NEW ELEMENTARY SCHOOL
 9801 HIGHLAND KNOLLS DR
 BAKERSFIELD
 CALIFORNIA
 93306
NEW MIDDLE SCHOOL
 4115 VINELAND ROAD
 BAKERSFIELD
 CALIFORNIA
 93306

ELECTRICAL MECHANICAL PLAN BUILDING A

SHEET IDENTIFICATION NUMBER
E-141A
 SHEET OF

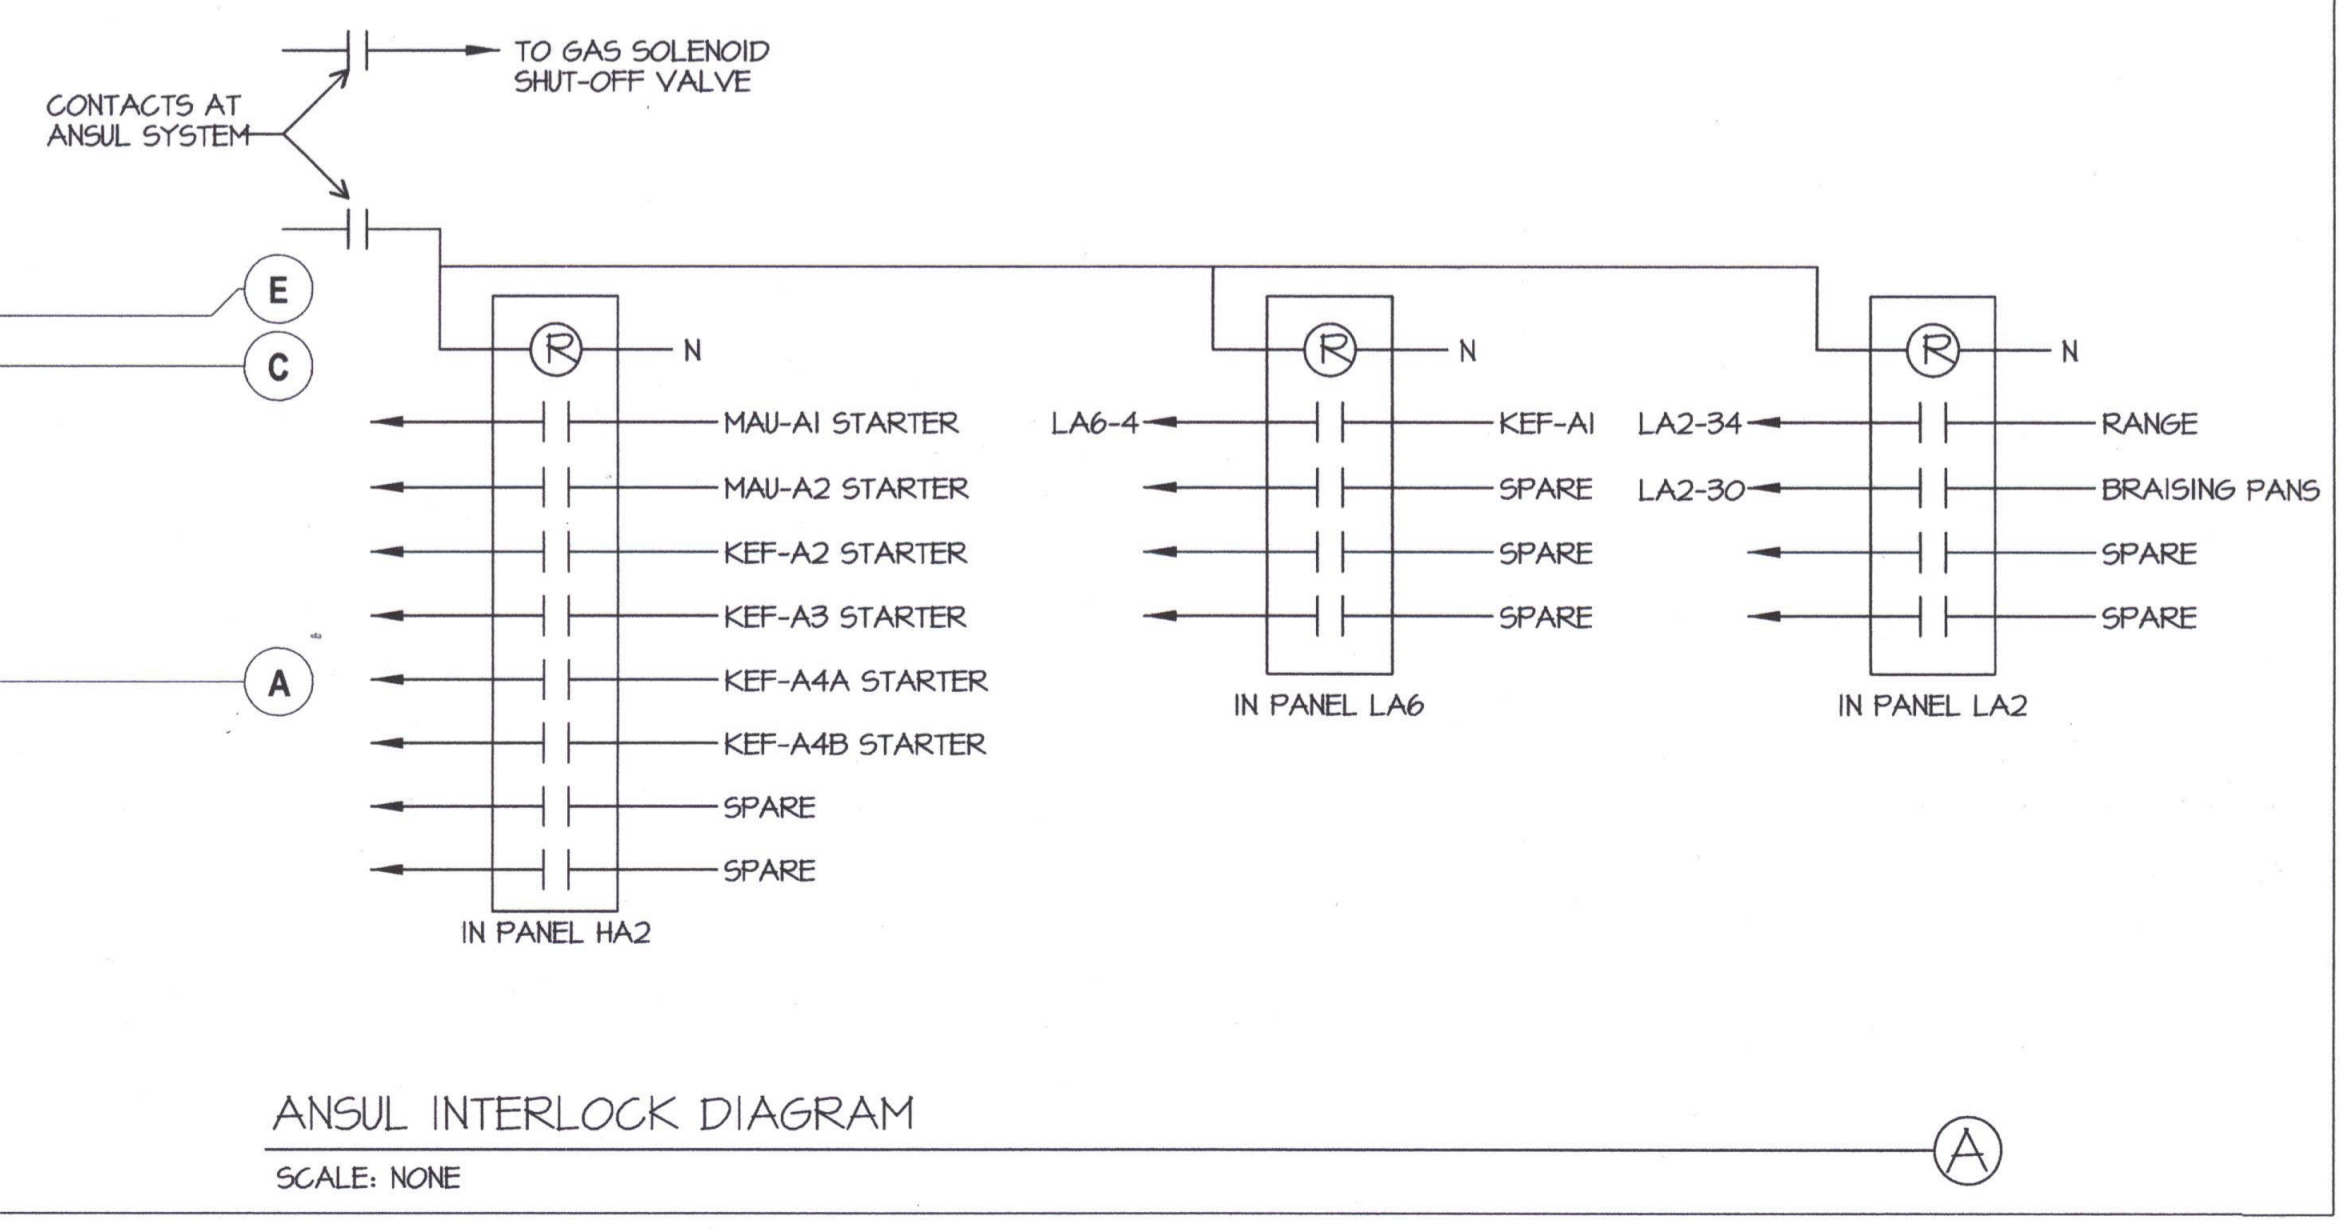
REQUEST:
 RCM Electric - 4/17/13
 Reference Sheet E-141A
 Per the Mechanical Electrical Plan for Building A, there are (3) exhaust fans to be installed on the roof of the Gym. There is no room on these exhaust fans to mount the disconnects to the units as shown. It is acceptable to install these disconnects on the parapet wall or the exterior perimeter wall and run the conduit under the roof from the disconnect location and stub up next to each exhaust fan for hook up? Please advise.
ANSWER:
 John Maloney - JMPE - 4/19/13
 Yes, this is acceptable.

RFI 309
 RCM Electric - 5/24/13
 Reference Sheets M-1414A & E-141A
 The Mechanical Plans for Building A show exhaust fan EF-1 to be installed on the roof just east of Gridline T5. However, the Electrical Plans for Building A do not show this exhaust fan or any power requirements for it. Is power panel designation and circuitry.
Answer:
 From: John Maloney, JMPE
 6/12/13 HP, 100 V, 100-4F-48
 Connect to LA2-4 with EF-48

RCM Electric - 7/27/13
 Reference Sheets E1214 & E141A
 The Electrical Plans for Building A show condenser unit A1 to be installed on the roof and fed from Panel HA1, Circuit 22,24. This condenser unit is to feed Room A133, however there are no power requirements shown to be installed inside Room A133 to power required inside Room A133 for condenser unit A17 to power required from condenser unit A1 on the roof to the inside of Room A133? If so, please advise on the requirements.

Answer:
 Ray Valenzuela - Infinity - 7/29/13
 This is the power requirements for INSIDE A133 for the data racks only. The power requirements for the roof top condensing unit remain and any other requirements JMPE has requested. My answer is confirmed. There is not a requirement for additional power other than the 3 phases inside A133, as the unit is self contained with its own distribution panels.
 Joe Covington - CMA - 7/27/13 We believe the connections are covered. That is why we are requesting the contractor makes sure he sees it the same way, or if there another question.
